# **i960<sup>®</sup> Rx I/O PROCESSOR SPECIFICATION UPDATE**

Release Date: March, 1997

Order Number: 272918-007

The i960<sup>®</sup> Rx I/O Processor may contain design defects or errors known as errata. Characterized errata that may cause the i960<sup>®</sup> Rx I/O Processor's behavior to deviate from published specifications are documented in this specification update.

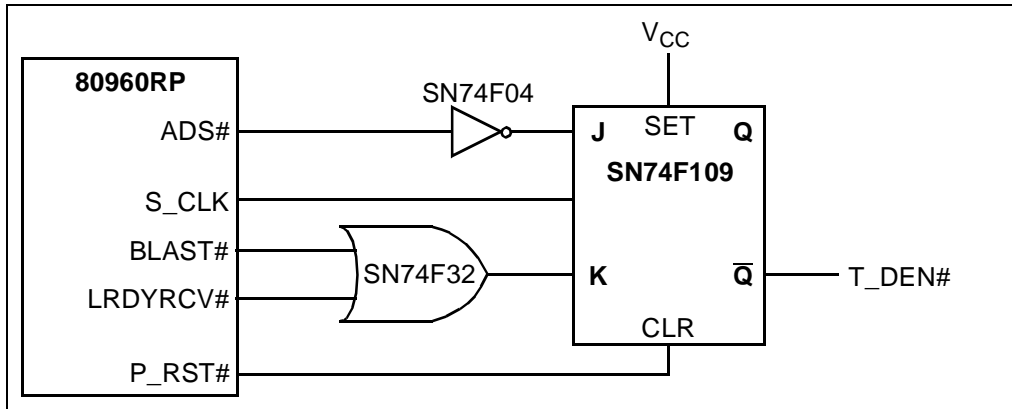
**ITEM:** When using an ICE in your 80960Rx system, the use of the Data Enable signal (DEN#) is not recommended. This clarification describes how DEN# operates and a recommended solution for using it with an In-Circuit Emulator (ICE).

*DEN# Operation:* When asserted, DEN# indicates data transfer cycles during a bus access. DEN# asserts at the start of the first data cycle in a bus access and de-asserts at the end of the last data cycle. DEN# can be used in conjunction with DT/R# to provide control for data transceivers connected to the data bus.

*Using DEN# with an In-Circuit Emulator:* For ICE users, it is not recommended that you use the 80960Rx's DEN# signal directly to your transceivers. When executing an ICE microcode transaction, the expected behavior is that DEN# would remain de-asserted during the entire transaction. However, DEN# asserts as described above. If your design uses DEN# to enable transceivers, the transceivers will be enabled. This may result in bus contention.

The 80960Rx is highly integrated; for most designs, the use of transceivers on the 80960 local bus is not necessary.
